HISTORIC AND DESIGN REVIEW COMMISSION

HDRC CASE NO: 2019-083
ADDRESS: 441 DONALDSON AVE
LEGAL DESCRIPTION: NCB 6695 BLK 4 LOT 10, W 16 FEET OF 9
ZONING: R-6,H
CITY COUNCIL DIST.: 7
DISTRICT: Monticello Park Historic District
APPLICANT: Yoko Taylor
OWNER: Yoko Taylor
TYPE OF WORK: Roof replacement
APPLICATION RECEIVED: February 11, 2019
60-DAY REVIEW: April 12, 2019
REQUEST:

The applicant is requesting a Certificate of Appropriateness for approval to replace the current asphalt shingle roof with a standing seam metal roof with a galvalume finish.

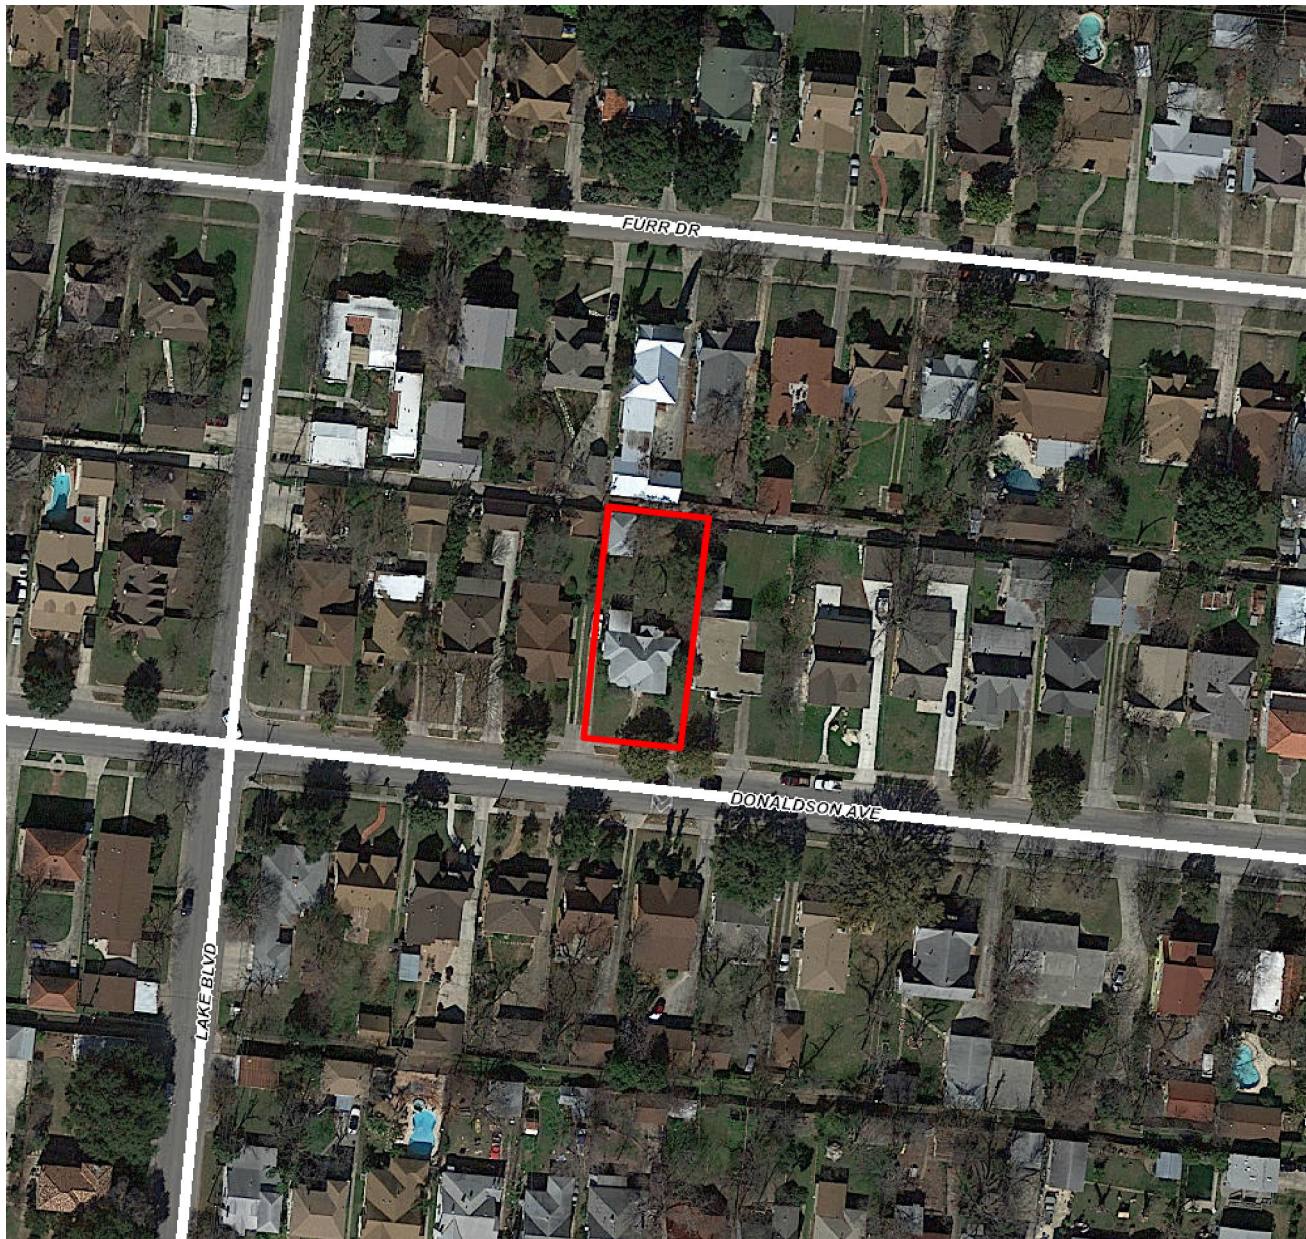
- d. Staff performed a windshield survey of the surrounding blocks within the Monticello Park Historic District on February 26, 2019, to determine if many of the roofs in the area had been replaced with standing seam metal. On Donaldson Ave, between cross streets Shearer Blvd and San Antonio Ave (three blocks), zero roofs have been replaced with standing seam metal. Photos of these homes are included in the exhibits. Overall in the district, approximately 20 of over 1,200 homes feature a roof replacement.

Staff does not recommend approval based on finding f. Staff recommends that an in-kind replacement of asphalt shingles be installed. If metal is desired by the applicant for its lifespan, then staff recommends a metal product that mimics the appearance of traditional shingles based on finding e.
